Project	<b>IEEE 802.16 Broadband Wireless Access Working Group</b> < <a href="http://ieee802.org/16">http://ieee802.org/16</a> >	
Title	<b>Updating figure for Master Priority Order</b>	
Date Submitted	<b>2007-11-04</b>	
Source(s)	Wu Xuyong Huawei, Huawei Industry Base, Bantian, Longgang, Shenzhen, China 518129	Voice: +86-755-28976776 Fax: <a href="mailto:wuxuyong@huawei.com">wuxuyong@huawei.com</a> ,
	Avi Freedman, Hexagen LTD.	<a href="mailto:avif@hexagonltd.com">avif@hexagonltd.com</a>
Re:	<b>IEEE 802.16-07/050: IEEE 802.16 Working Group Letter Ballot #29: Announcement (2007-10-05)</b>	
Abstract	<b>Updating figure for Master Priority Order</b>	
Purpose	To consolidate the 16h draft.	
Notice	This document has been prepared to assist IEEE 802.16. It is offered as a basis for discussion and is not binding on the contributing individual(s) or organization(s). The material in this document is subject to change in form and content after further study. The contributor(s) reserve(s) the right to add, amend or withdraw material contained herein.

## Updating figure for Master Priority Order

Figure h52 — Priority Order for a 3 system community

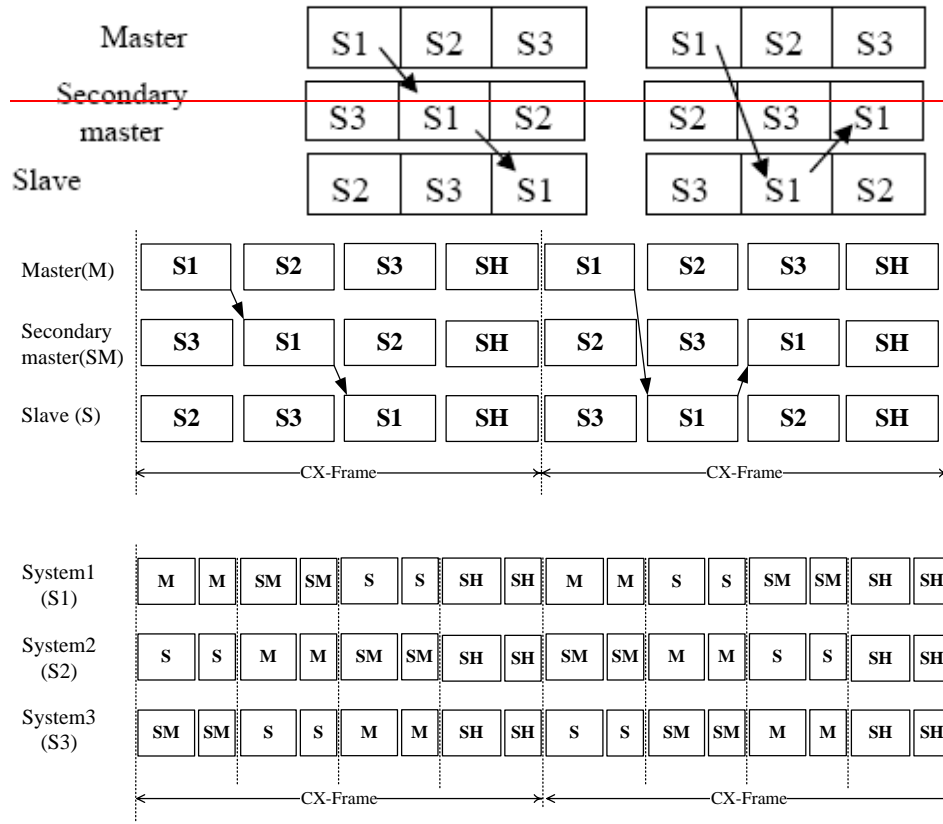
*The following figure in illustration of Master Priority Order should be update accordingly to show it in CX-Frame structure.*

~~Let S1 denote the master system of the first frame (CX\_MAC\_NO=1), S2 the master system the second frame (CX\_MAC\_NO=2) and S3, the master system of the third frame (CX\_MAC\_NO=3). In the first set of 3 frames the systems priority will be demoted from frame to frame:~~

~~In case the MAC frame number (CX\_MAC\_NO) is on above a multiple of 6 (CX\_MAC\_NO mod 6=1), S3 will be the secondary master in the frame~~

~~In case CX\_MAC\_NO mod 6 =2, S1 will be the secondary master~~

~~In case CX\_MAC\_NO mod 6 =3, S2 will be the secondary master~~

~~In the second set of 3 frames the systems priority will be demoted from frame to frame~~

~~In case CX\_MAC\_NO mod 6 =4, S2 will be the secondary master~~

~~In case CX\_MAC\_NO mod 6 =5, S3 will be the secondary master~~

~~In case CX\_MAC\_NO mod 6 =0, S1 will be the secondary master of sub frame 3.~~

Let S1 denote the master system of the first frame (MAC Frame=4N), S2 the master system the second frame (MAC Frame 4N+1) and S3, the master system of the third frame (MAC Frame 4N+2). In one CX Frame the systems priority will be demoted from frame to frame:

- In MAC frame number 4N S3 will be the secondary master in the frame
- In MAC Frame 4N+1, S1 will be the secondary master
- In MAC Frame 4N+2, S2 will be the secondary master

In the following CX-Frame the systems priority will be promoted from frame to frame

- In MAC Frame 4(N+1) S2 will be the secondary master
- In MAC Frame 4(N+1)+1, S3 will be the secondary master
- In MAC Frame 4(N+1)+2, S1 will be the secondary master

Figure h52 shows the priority order for 3 systems in different sub-frame structures. The common parts and TX/RX boundaries are omitted. The arrows show the priority demotion and promotion for system S1.
